Item #	Request	Response
Subsidence Advisory NSW (letter dated 1 December 2021)		
1	Clarification on whether the estimated number of homes that will be damaged is inclusive of non-conventional subsidence risks from mining under steep “Wianamatta Shale” slopes and previous slope failures.	<p>The estimated number of houses assessed to be damaged considers the potential for non-conventional subsidence due to mining beneath steep slopes with Wianamatta Group shales. The ACARP method (Waddington, 2009) for assessing potential impacts on houses was developed based on experience of mining at several collieries including Appin, West Cliff and Tahmoor. These collieries include areas with steep slopes comprising of Wianamatta Group shales.</p> <p>Some areas of the topography associated with Razorback Range are more incised than these previous mining areas. However, the majority of the houses within the Study Area are located on Razorback Range. There are only eight houses (5 % of the total) located on the top of Razorback Range and above the longwall mining area; however, these houses are setback from the more incised areas (i.e. grades greater than 1 in 2) of the range. There are no houses l

Figure 1 Sensitivity to extraction height (T), Ditton method and Tammetta method

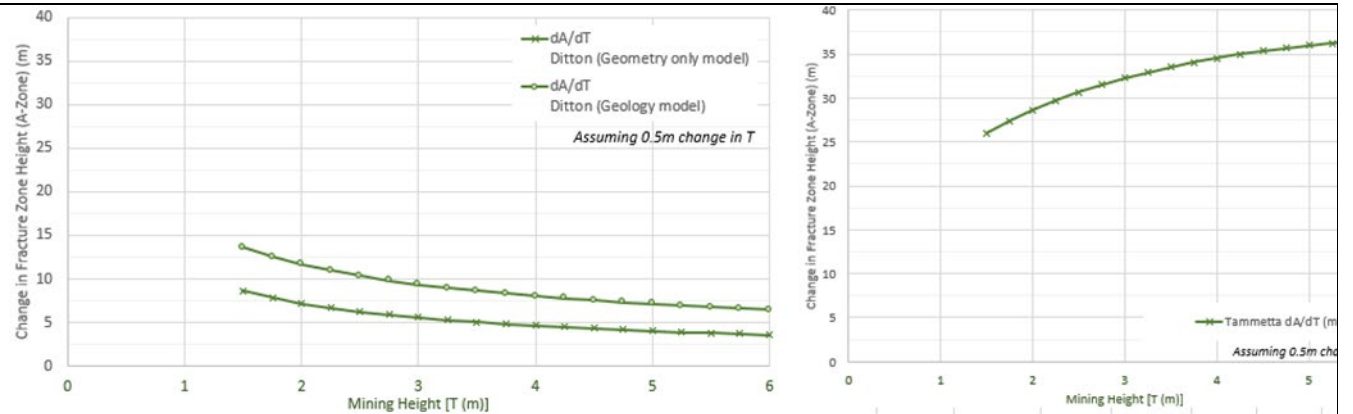
7	<p>Use of Tammetta's equation suggests a height of connective fracturing of 338-360 m for a panel width of 324 m and extraction height of 3.3 m. Such a height of connective fracturing would likely take it up into the Bulgo Sandstone and Hawkesbury Sandstone.</p>	<p>The existing Appin Model fracture heights are determined using the Ditton algorithm. The Ditton algorithm is preferred over the Tammetta method at Appin Mine for the following reasons:</p> <ol style="list-style-type: none"> 1. There is no evidence (e.g. site measurements) that favours the Tammetta formula over the Ditton formula at Appin Mine. 2. Tammetta algorithm is highly sensitive to extraction height (T) and therefore, overestimates fracture zone height with increase in extraction height. This is due to the nature of the Tammetta algorithm which uses a power law (exponent of 1.4). As shown in Figure 8 below, the power law causes large increases in fracture zone height for small increases in extraction height. The Ditton method uses an exponent of 0.5 which is consistent with laboratory evidence (Whittaker and Reddish, 1989).

3. Effective thickness of the strata (t') which supports the larger mining height is not included in the Tammetta algorithm. Therefore, the algorithm disregards this parameter and tends to overestimate the fracture height. A sensitivity analysis was carried out with the aim of comparing the fracture zone height using different approaches. The sensitivity analysis included the following methods:
 - Ditton method with $t'=20$ m [base case];
 - Ditton method with $t'=15$ m;
 - Ditton method with $t'=10$ m; and
 - Tammetta method.

The results of the sensitivity analysis are presented in Table 8 below. As it can be seen in the table, Ditton with $t'=10$ m results in fracture height values consistent with the Tammetta method. A study by Ditton and Merrick (2014) on longwall mines in the NSW coalfields indicated that $t'=15$ m to 20 m is considered appropriate for the Southern Coalfield (Figure 9). The 2014 study considered $t'=10$ as an extreme value (i.e., worst case scenario).

Given that the depth of cover above the Appin longwalls varies between 530 m and 750 m, the exiting Appin groundwater model uses Ditton calculation with $t'=20$ for the longwalls simulated in the model. However, as a part of the new round of updates to the groundwater model, SLR suggests a Ditton method with a variable t' (between 15 to 20) be used in calculation of fracture height for different depth of cover areas above the Appin longwalls.
